PAPE, ZACHARY

Office Action Summary

10/815,372

DETAILED ACTION

Fig 1

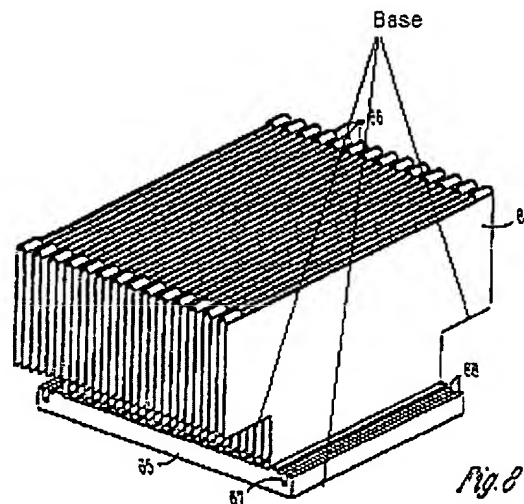
With respect to claims 17 and 18, as best can be understood by the Examiner, Bryant et al. in view of Wu teach the limitations of claims 1 and 6 above and further teaches that the base of the heat sink (32) has a long side and a short side (See Fig 2), whereby a boundary (The defined by the inside edge of 40a, 40b, 38a, and 38b) of the mounting device is located within and under the heat sink, but fails to teach that the mounting device has a length shorter than the long side of the base and a width shorter than the short side of the base. Lofland et al. teaches a mounting device (90) having a length (Defined by 92b, 92d) shorter than the long side of the base (See Present Office Action Fig 1 below) of a heat sink, and a width (Defined by 92a, 92c) shorter than the

short side of the heat sink (See Fig 10). It would have been obvious to one of ordinary skill in the art at the time the invention was made to combine the teachings of Lofland et al. with that of Bryant et al. to provide appropriate thermal dissipation for the needs of the electrical device (Column 3, Lines 52-55).
